## **REVIEW OF THE KINGSTON FOSSIL PLANT ASH SPILL ROOT CAUSE STUDY AND OBSERVATIONS ABOUT ASH MANAGEMENT**

2008-12283-02  
July 23, 2009

Peer Review of the AECOM Root Cause Analysis of TVA Kingston Dredge Pond Failure on December 22, 2008

**Figure 2**  
Peer Review of the ATOMS Soil Gas Analysis of 1140 Kunkle Bridge Fund Project on December 12, 2008  
Tennessee Valley Authority—Office of the Inspector General  
July 2009 • Prepared by Volume 1 Miller & Associates, Inc.

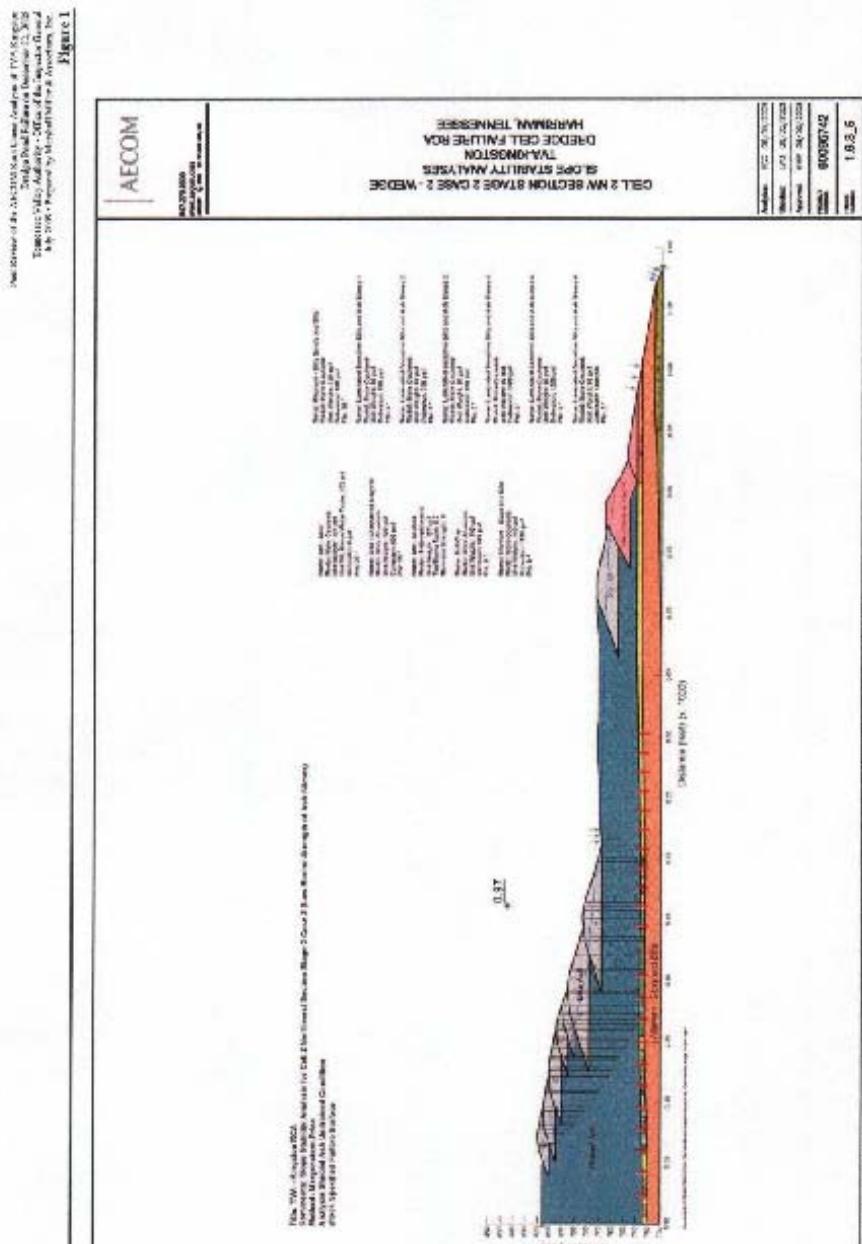
AECOM discussed the thin layer of slimes beneath the dikes of Dredge Cell 2, per item 3 above, which was discovered during its subsurface investigation (see **Figure 2**). Slimes do not exist beneath Dike C. Although the properties of this slime layer suggest it as a potential slippage surface based upon mathematical modeling, it is MM&A's opinion that it is not the only possible slippage surface. AECOM documented that slimes were not found in some locations, were not of consistent thickness, and had properties very close to those of the ash material itself.
